Access Compliance Report

Public Rights-of-Way

Intersection ID: 28281	Main Street: FAIRHOPE_CT	Cross Street: LANDING_GREEN_DR	Location: NW
ADA ID: CAC534EAD28E	Ramp Type: Perp	Initial Pass/Fail: Pass	Overall Compliance: No
Severity Score: 15			
Codes/Mitigation Info/Possible Solution		Field Measurements/Component Compliance

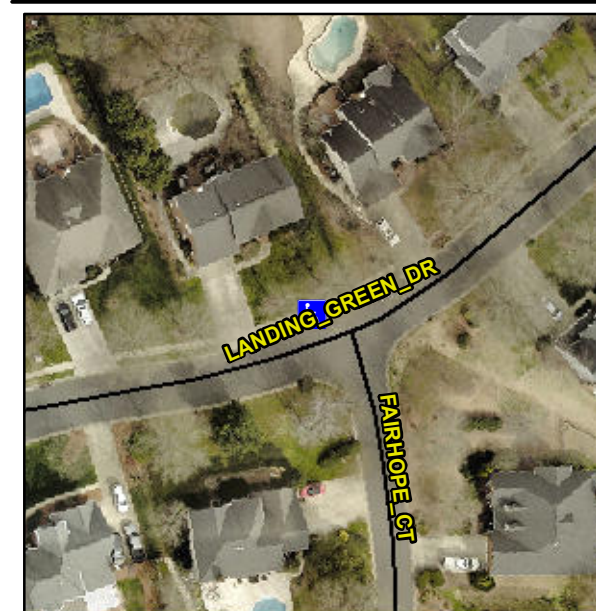
Not Found, R304.2.1, R304.2.2-Perp, R304.3.2-Para, R305.2, R302.7, R302.7.2

Compliance	Description	Data	Compliance	Description	Data
N/A	Ramp Length (in)	49.0	Yes	Ramp Slope (%)	5.9
Yes	Ramp Width (in)	48.0	Yes	Ramp XSlope (%)	0.3
N/A	Flare Type LT	Sloped	N/A	Flare Type RT	N/A
N/A	Flare Slope LT (%)	2.2	Yes	Flare Slope RT (%)	3.0
N/A	Flare Traversable LT?	Yes	N/A	Flare Traversable RT?	Yes
No	Landing Length (in)	47.0	Yes	DWS Provided?	Yes
Yes	Landing Width (in)	48.0	Yes	DWS Contrast?	Yes
No	Landing Slope (%)	3.8	Yes	DWS Length (in)	24.5
Yes	Landing X Slope (%)	1.0	Yes	DWS Full Width?	Yes
N/A	Landing Curb? (Y/N)	No	No	DWS Offset (in)	2.5
N/A	Shared Landing?	No			
No	Gutter Ponding?	Yes	Yes	Gutter Slope (%)	4.0
No	Gutter Lip Ht (in)	1.0	Yes	Gutter X Slope (%)	1.6
N/A	Painted X Walk1?	No	N/A	Painted X Walk2?	N/A
	X Walk 1 Direction	To SW		X Walk 2 Direction	N/A
N/A	X Walk 1 Width (in)	N/A	N/A	X Walk 2 Width (in)	N/A
	X Walk 1 Slope (%)	2.7		X Walk 2 Slope (%)	N/A
	X Walk 1 X Slope (%)	0.9		X Walk 2 X Slope (%)	N/A

N/A	Ramp inside XWalk1?	N/A	N/A	Ramp inside XWalk2?	N/A
	Road Slope (%)	N/A	N/A	Clear Space?	Yes
	Road X Slope (%)	N/A	N/A	Clear Space to XWalk (in)	N/A
Yes	Any Obstructions?	No	Yes	Storm Grate/Utility Hazard?	No
	Obstruction Type			Storm Grate/Utility Type	
		N/A			N/A
			Yes	Surface Condition? (G/P)	Good

Remove & Replace Entire Ramp.
